SERVICE BULLETIN

NUMBER 007

DATE 09-29-89

EVACUATION OF AIR CONDITIONING REFRIGERATION SYSTEMS

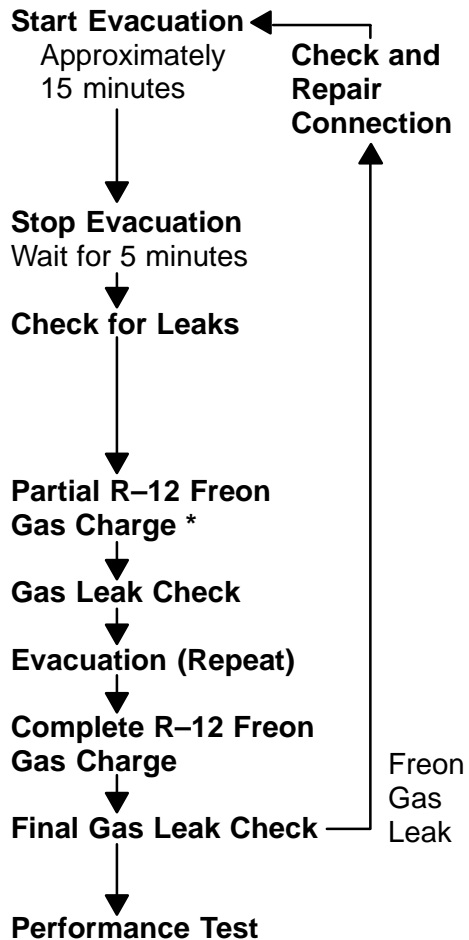
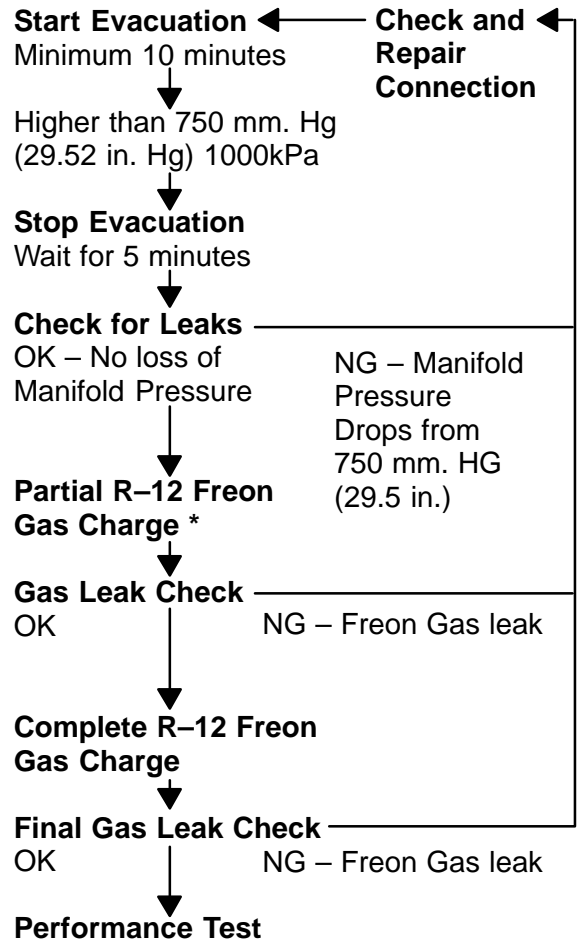
The air conditioning refrigerant evacuation procedure has been revised to reduce evacuation time and minimize the release of CFC gas into the atmosphere. Please follow this new procedure for all Toyota vehicles.

PREVIOUS PROCEDURE

NEW PROCEDURE

* Charge Freon gas until the low pressure gauge reaches 1 kg/cm².
